RESOLUTION NO. 22-278

A RESOLUTION OF THE CITY COMMISSION OF THE CITY OF KEY WEST (CITY) APPROVING A CHANGE ORDER IN THE AMOUNT OF \$40,446.34 FOR ADDITIONAL WORK NECESSARY FOR INSTALLATION OF THE VFD FOR EFFLUENT PUMP NO. 1, UNDER THE CONTRACT AWARDED TO D.N. HIGGINS, INC. IN RESOLUTION 20-048; AUTHORIZING ANY NECESSARY BUDGET TRANSFERS AND AMENDMENTS; AUTHORIZING THE CITY MANAGER TO EXECUTE NECESSARY DOCUMENTS UPON ADVICE AND CONSENT OF THE CITY ATTORNEY; PROVIDING FOR AN EFFECTIVE DATE

Subject: Approve change order proposal from D.N. Higgins, Inc. for the install of the effluent pump no. 1 VFD at the Richard A. Heyman Environmental Protection Facility.

Key West VFD Replacement

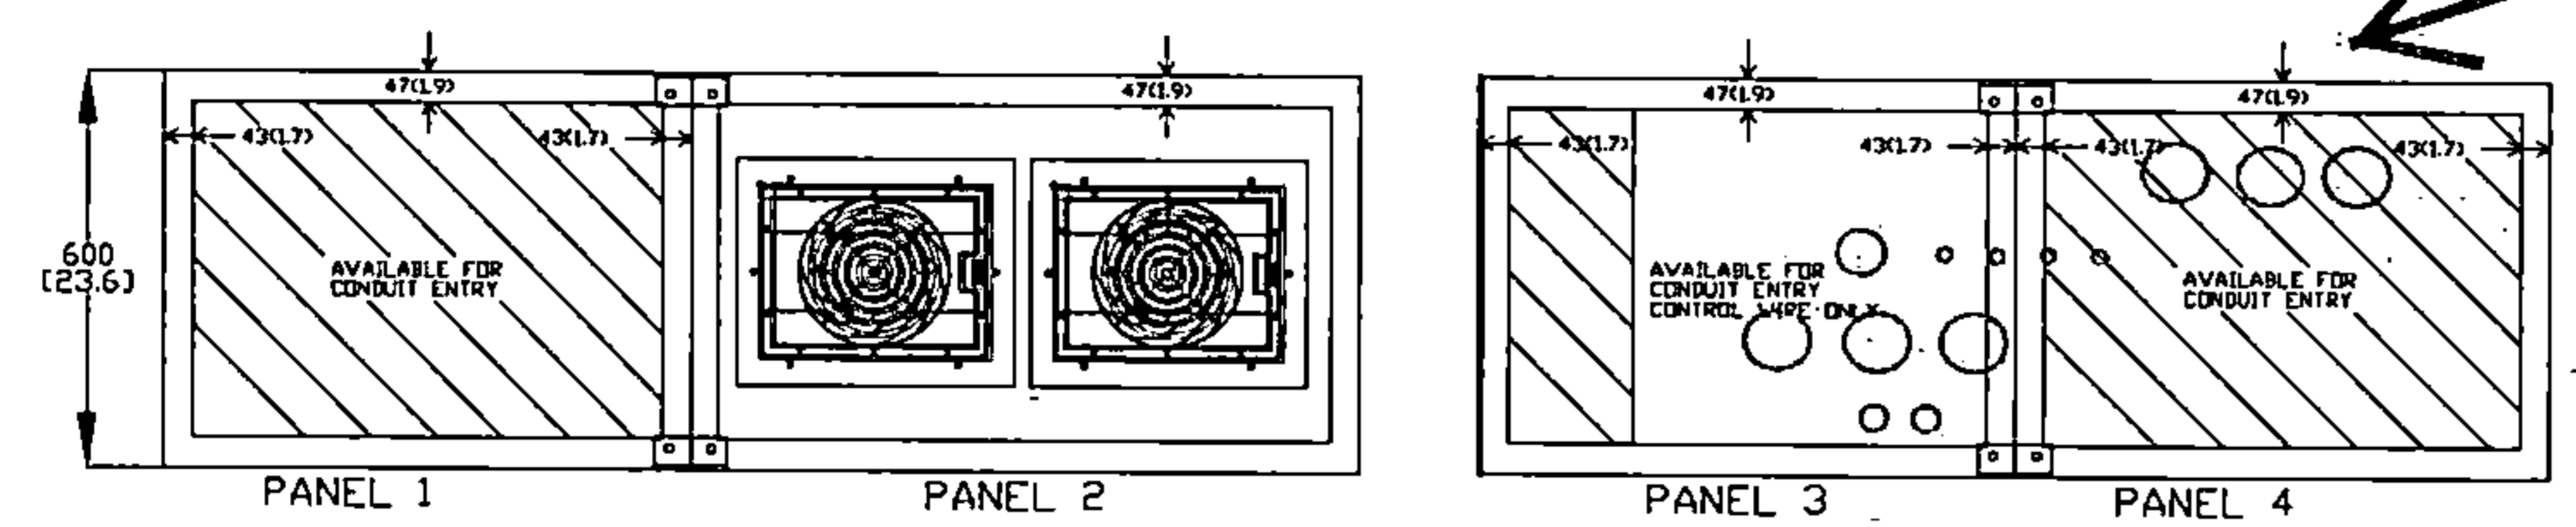
- 1) The existing feeders from the electric room to the existing iso transformer are not long enough. See pic#1
 - a. Advised solution would be to install a terminal block in the new pulse transformer. See pic#2
 - b. Note* If a terminal block is not acceptable then we will have to replace the feeders (very expensive).

- 2) We cannot reuse the wire from the existing iso. transformer to the existing VFD because the new pulse transformer feeds the new VFD through four high stranded 1000 volt DC cable. Factory cables are not long enough.
 - a. Solution, we are going to have to purchase new 1000v DC Cable. See pic#3

Existing feeders from electric room to new Iso. Xformer are not long enough to land in the new Pulse Transformer

Factory DC high voltage cable, intended to be installed from Pulse Xformer to New VFD, but it is not long enough.

Install 9 new 500mcm
XHHW Copper
feeders

Install new Power
Distribution block to
land existing feeders,
install new feeders
from block to breaker

Run existing feeders
to terminal block

DIMENSION DRAWING
ITEM 0001
EFFLUENT PUMP P-6-2-1
Drawn by: PS Date: 4/4/19

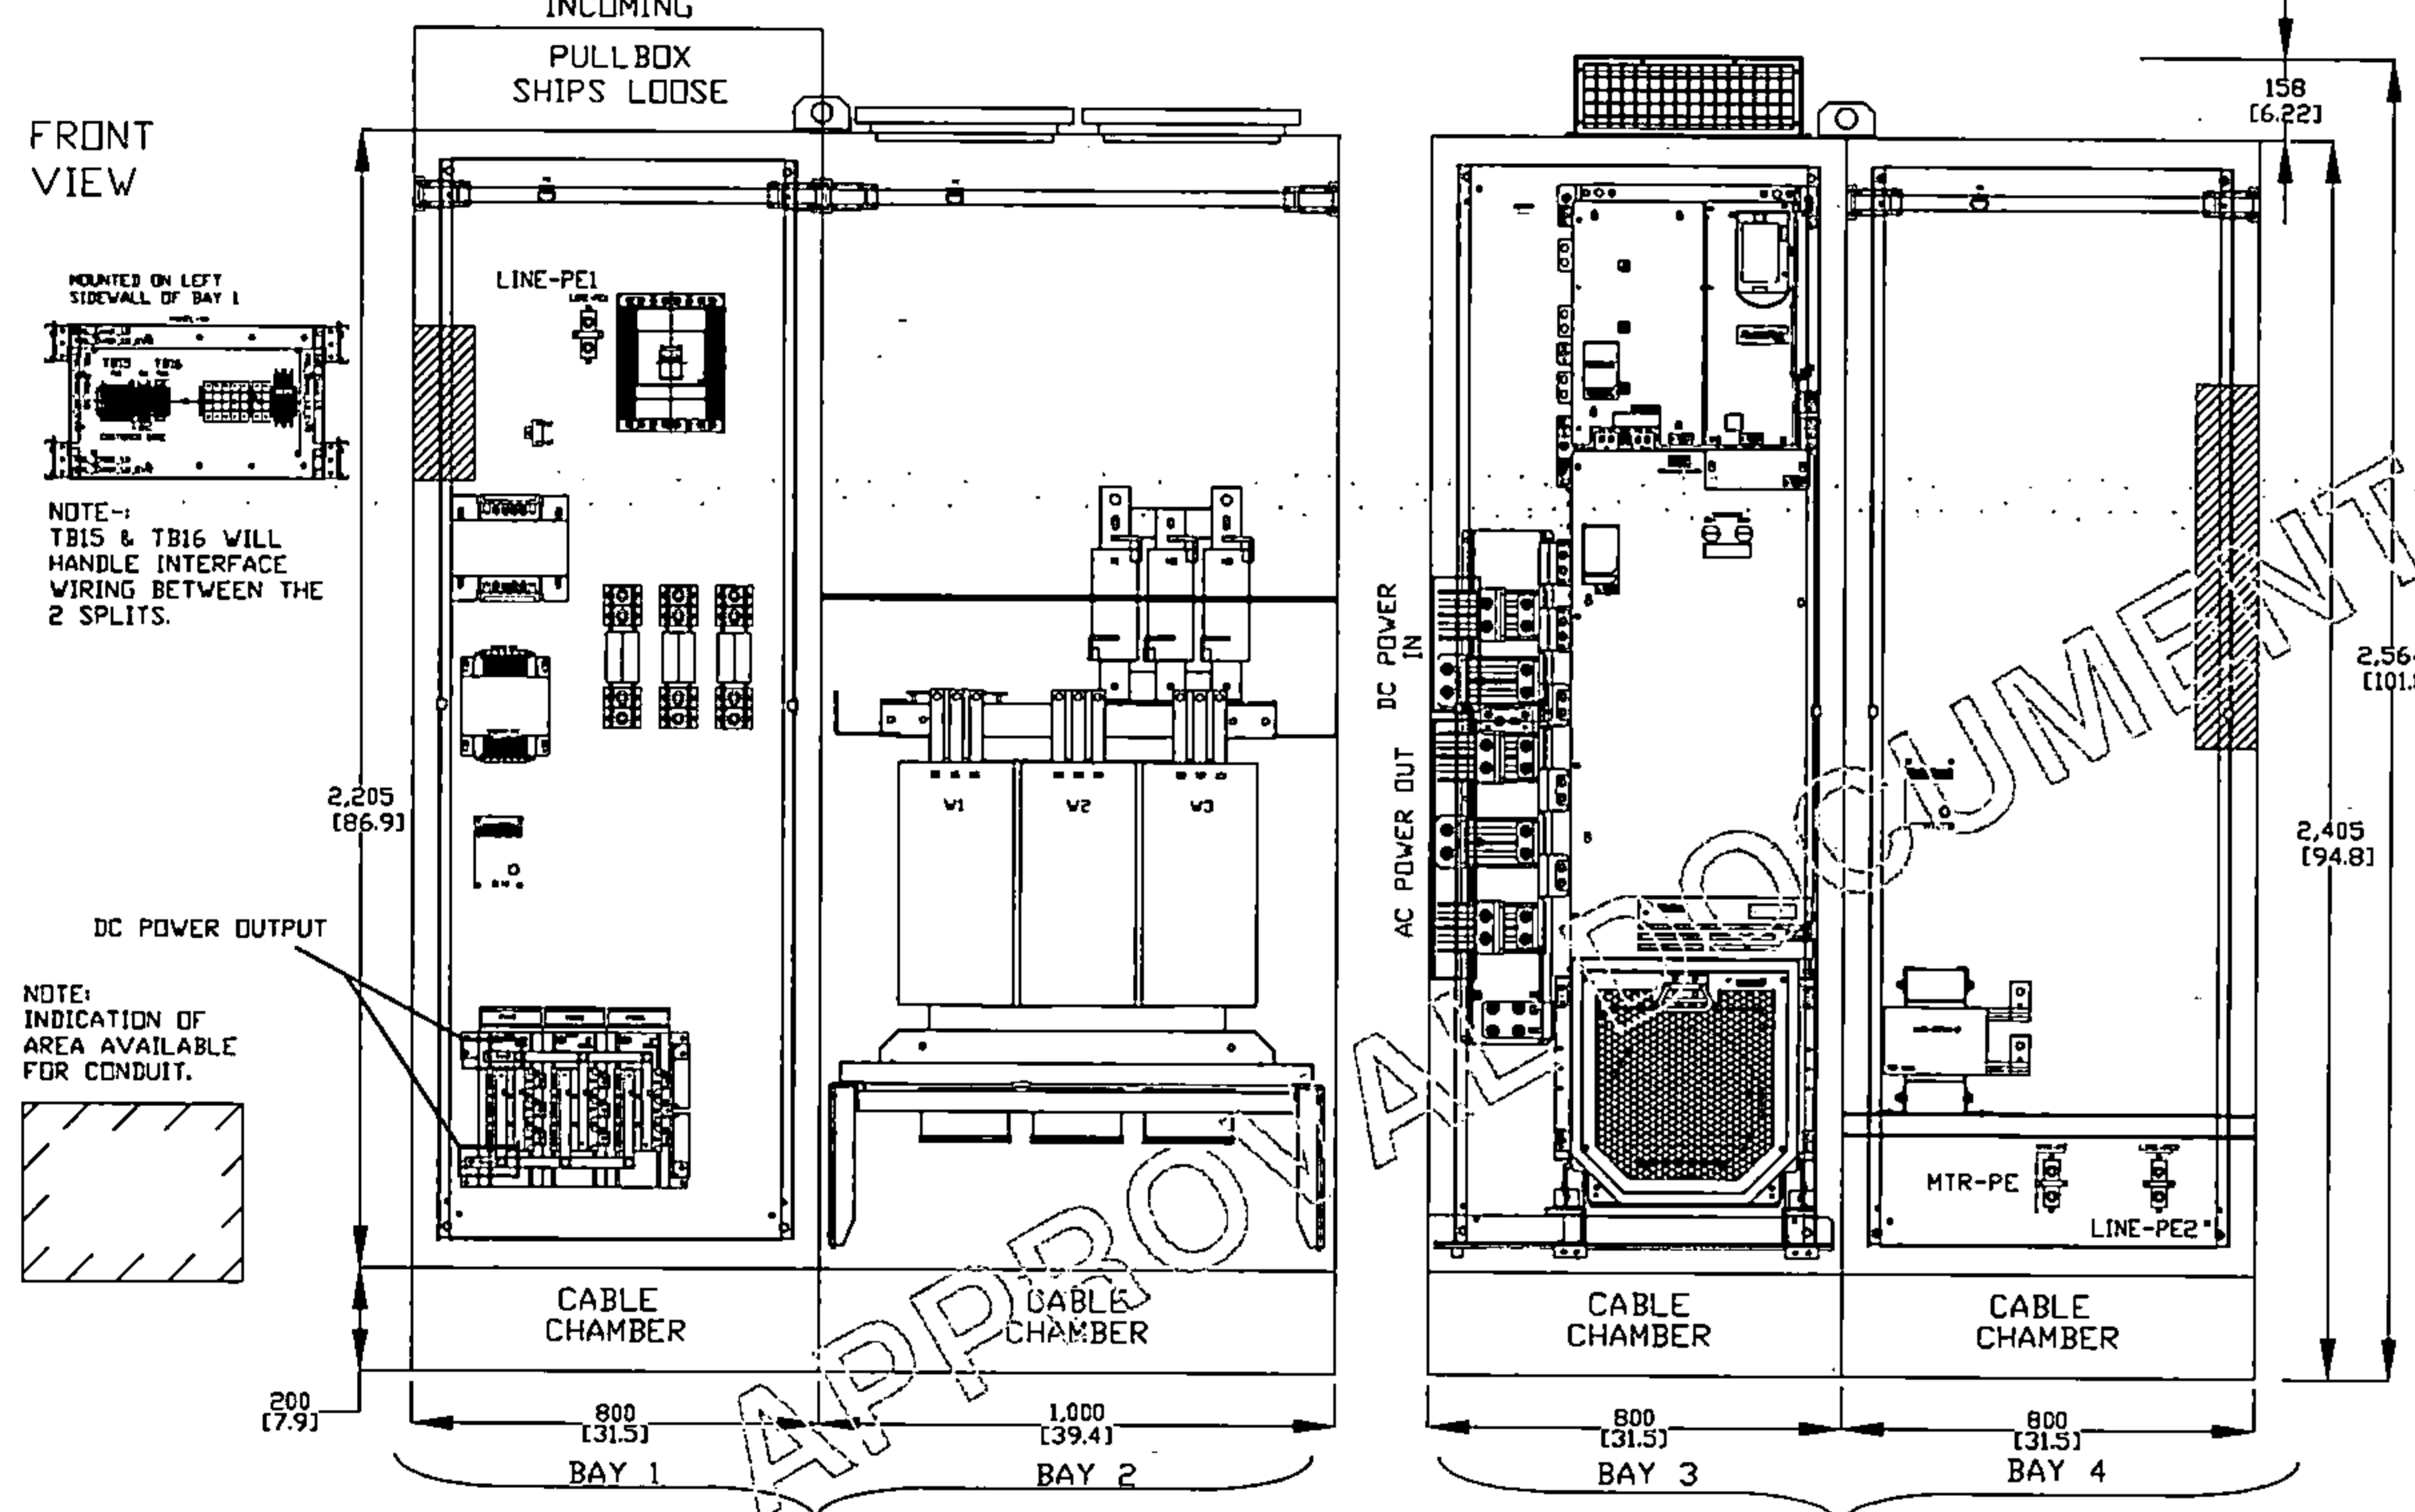
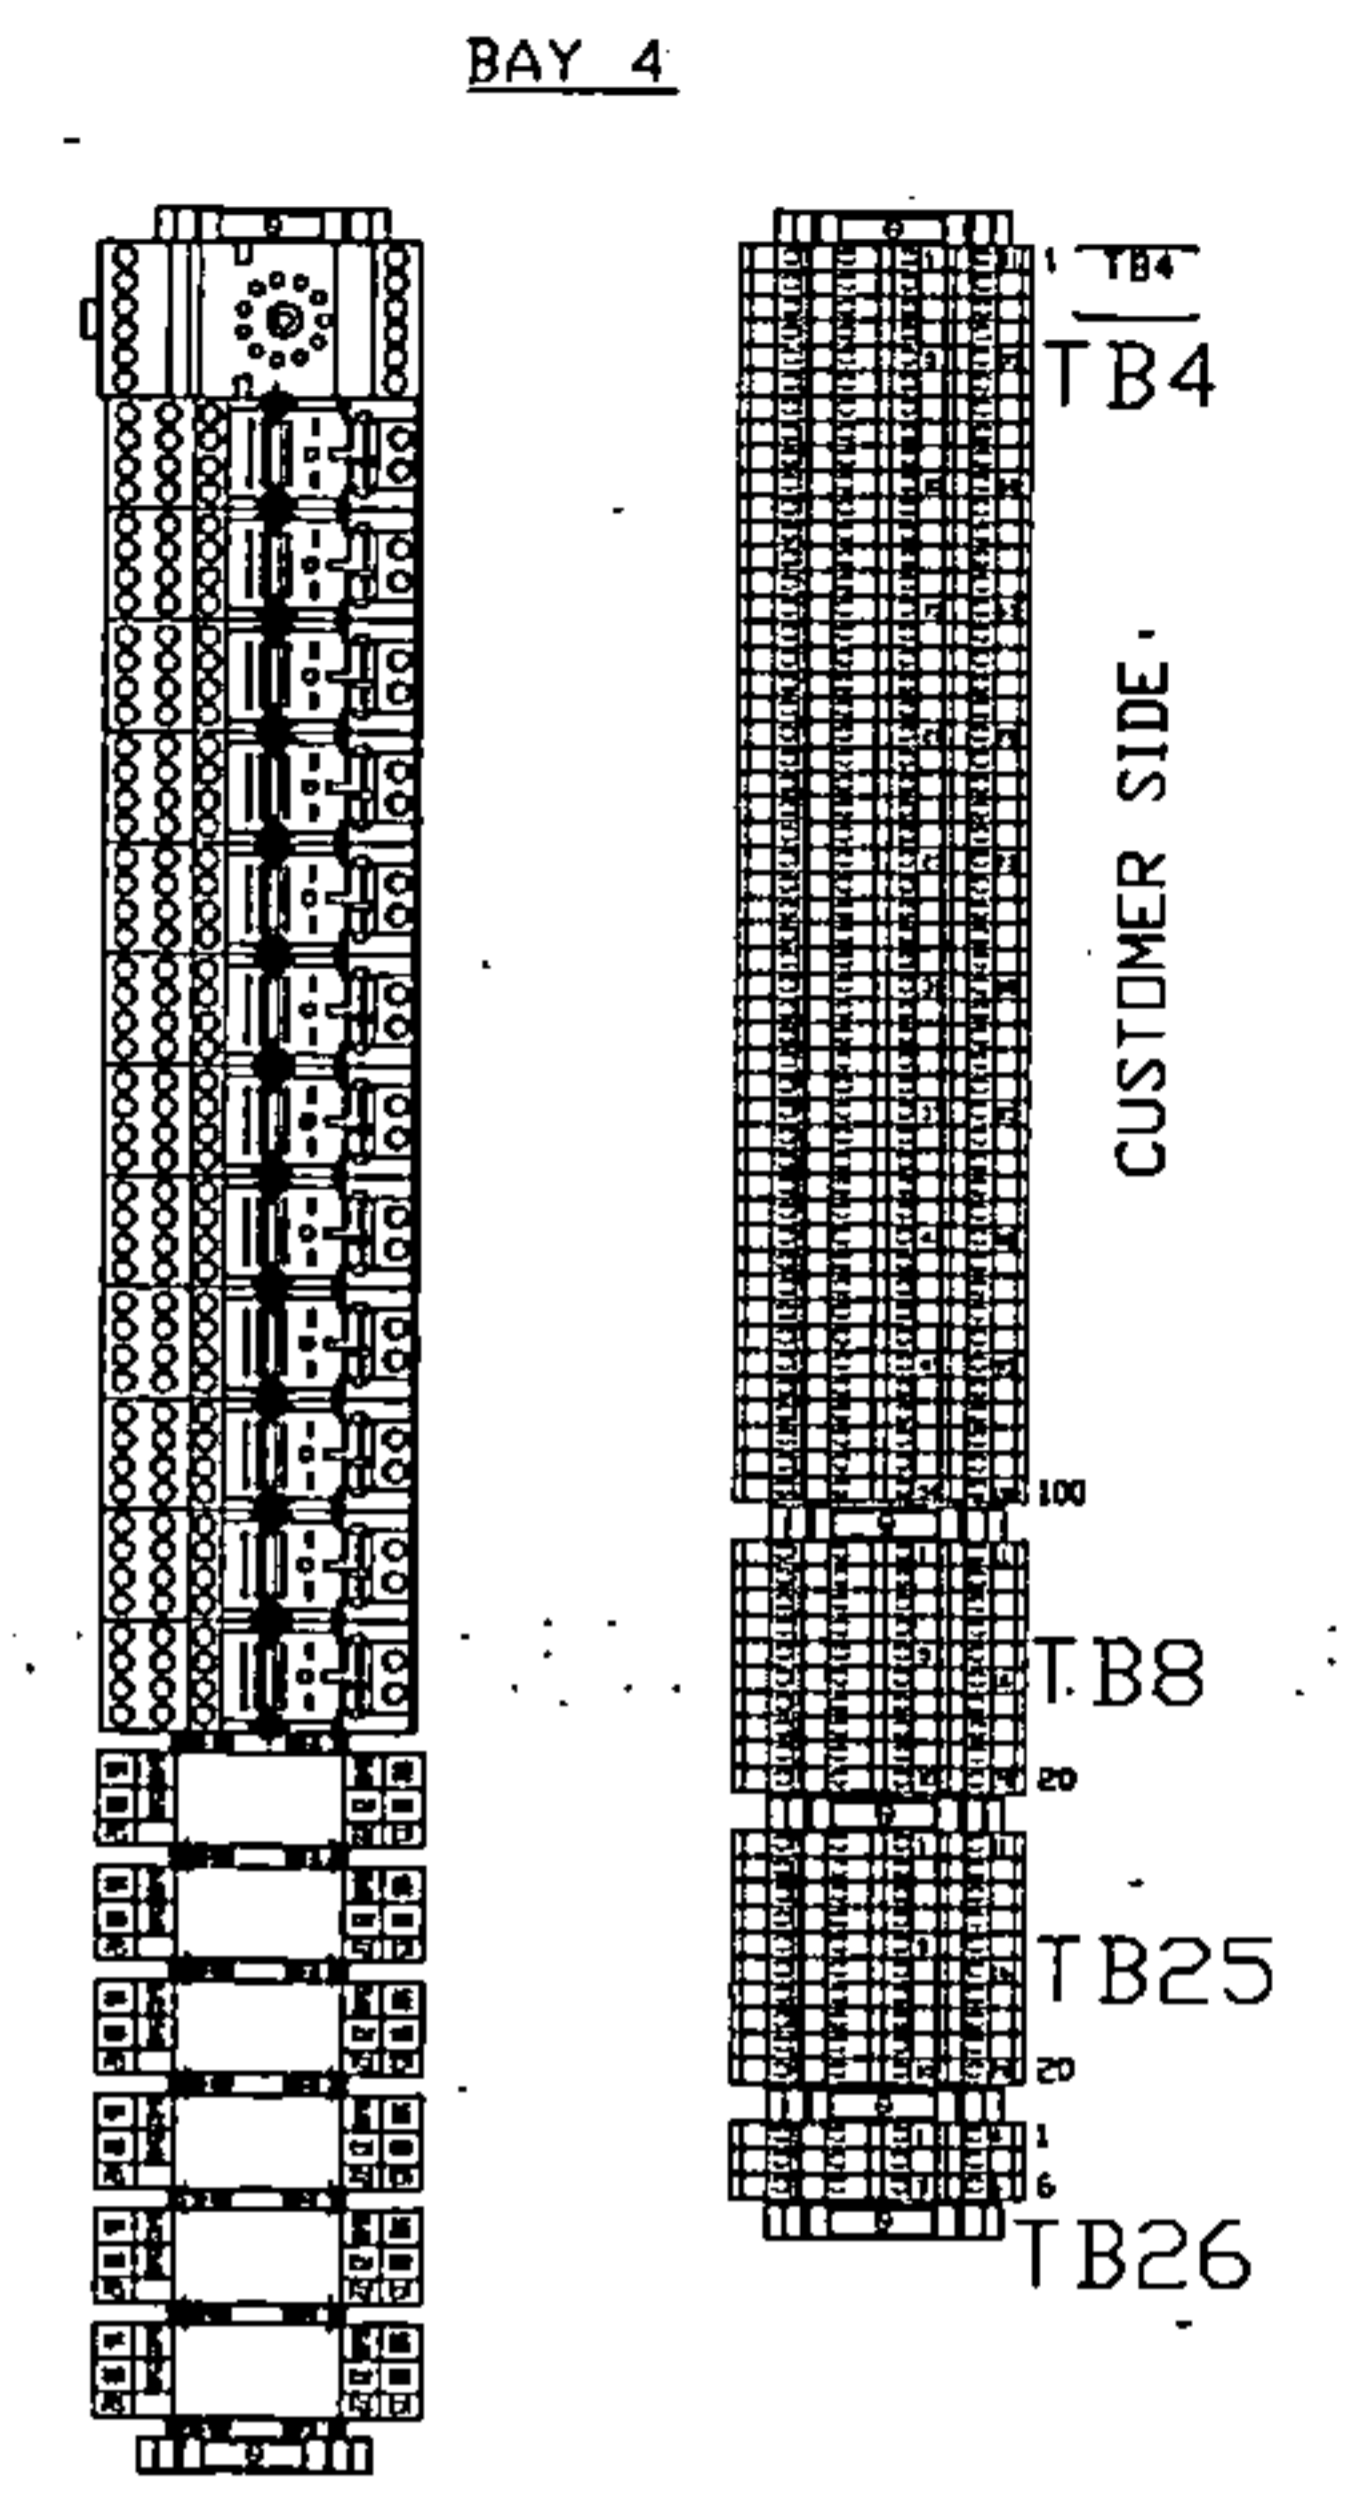
- 3) The conduit arrangement above the existing VFD will not fit in the new VFD window. See pic#4
 - a. Solution, cut the conduit close to the ceiling and install grounding bushing and free wire to the new VFD window. (as done previously) We will have to install "C" condilets to accommodate pulling wire back. See pic#5

Existing conduit layout will not fit into new conduit window

Cut existing
conduit and
install grnd
bushing then
free wire to new
VFD, as done
previously

Install "C"
Condilet

Install
Compression
Male Adapter

Mechanically
Cut Coupling
